Subject: Diesel Engine Lubrication

Detroit Edison agreed to supply information regarding the manufacturer suggested piping modification to the lube oil system of the Emergency Diesel Generators. These modifications will help assure engine lubrication for all starts. The design and test information is provided in the attached Colt Industries Engineering Report (File Number VTS-985-082881-01R).

SUBJECT ENGINE PRELUDE/KEEPWARM SYSTEM REQUIREMENTS

REPORT TITLE KEEPWARD L.O. SYSTEM MODIFICATION
NUCLEAR STANDBY UNITS (OP ENGINES)

FIGURE 1 - L.O. CIRC.
ELECTRICAL SYSTEM
REF: 11867837

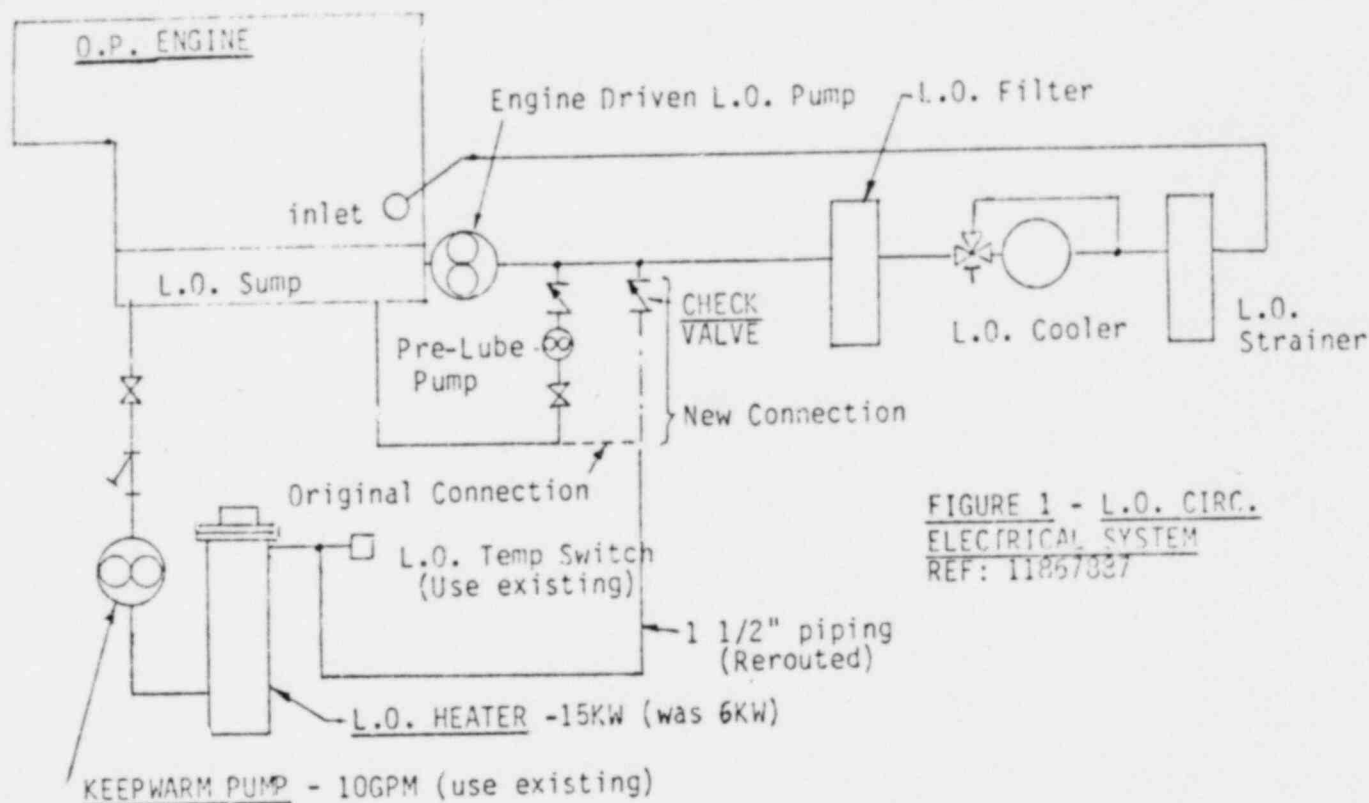
Figure 1 shows the final system arrived at resulting from this development program. In summary, the lube oil circulating system was modified so that oil was delivered to the system at a point near the engine driven pump discharge, thru a check valve. The L.O. circulating heater was increased in capacity from 6 to about 15KW in order to maintain L.O. temperature (viscosity) and to account for the greater losses in the L.O. system because of the increase in the extent of piping thru which the oil would then flow.

Mechanical (Ref: Figure 1)

1. Change the 6KW L.O. heater to 15KW. Information from the most probable vendor indicates that a 15KW heater unit, not exceeding 15 watts per square inch of heater element, can be provided and can be accommodated on the skid in place of the present heater, using the same mounting arrangement. The new unit is about the same size as the present J.W. heater. L.O. inlet would be at the same location.
2. Change the piping from the discharge of the new heater to a point in the piping at the discharge of the engine driven pump (at the same location to which the prelube pump is now piped), including a check valve (same check valve as used with the prelube piping). Include a connection for location of the thermostatic switch (OHT) at the heater outlet. 1 1/2" piping is required.
3. Block off the cross to which the old connection was made (drain to front of L.O. sump).

FIGURE 2
ELECTRICAL SYSTEM
MODIFICATION
REF: 11867708
SHEET 2

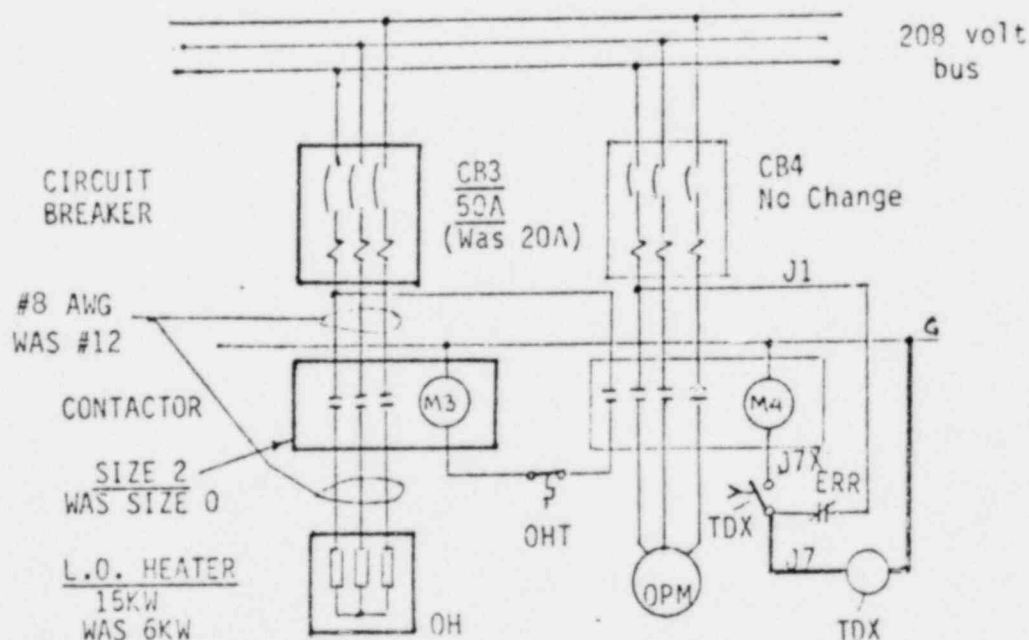
Electrical (Ref: Figure 2)

1. Relocate conduit to heater connection and thermostatic switch connection as required (raised approx. 12").
2. Replace CB3 (20A) with a 50A unit (Same as CB1). (Our drawings do not indicate source on this item. Customer should identify circuit breaker unit manufacture so that it can be duplicated.)
3. Replace M3 contactor with 11905926 (Cutler Hammer C20DN3A) (Same as M1).
4. Replace wiring (3 wires each) between CB3 and M3 and between M3 and the heater (OH) with #8 AWG (was #12).
5. Add a Time Delay Relay - TDX (FM #11904628 - Agastat 7012AH) in the circuit as shown on the electrical schematic - Figure 2.

(One side of the coil to wire G, other side of coil to wire J7. One side of switch to wire J7 [removing J7 from coil of M4]. New wire J7X between other side of switch [N.O. contacts] to coil of M4 (from which wire J7 was removed.)

6. TDX has a range from 3 to 30 minutes and should be set at 10 minutes.

FIGURE 3 - ENGINE INTERNAL MODIFICATIONS

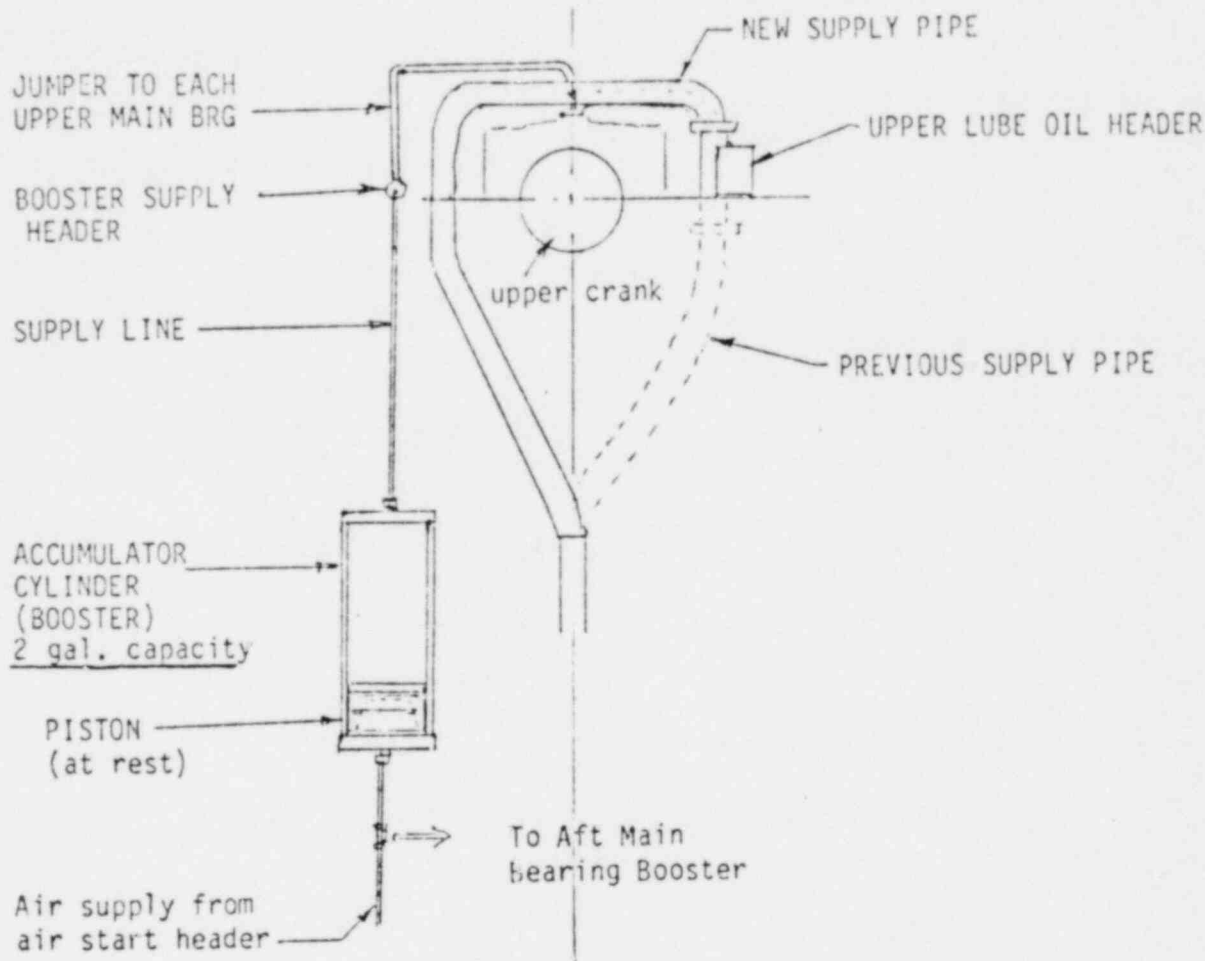
MODIFICATION TO INTERIOR OF ENGINE (Ref: Figure 3)

This modification consists of rerouting the supply to the upper L.O. header such that the header will not readily drain (a loop of tubing up over the crankshaft above the level of the header). See Figure 3.

This modification also consists of adding a lube oil booster/accumulator system to the upper crankline, similar to that used on the aft lower main bearing. This booster system fills with oil during normal engine operation. The next time the engine is started, the lube oil accumulated in the cylinder assembly is forced by starting air pressure acting on the opposite side of a piston, to be fed into the bearings along the upper crankline, thus filling the bearings with oil as the engine begins to be rotated in starting.

No external connections are required with this system as the air supply to the accumulator is tied internally to that of the aft main bearing booster system. The system is self regulating.
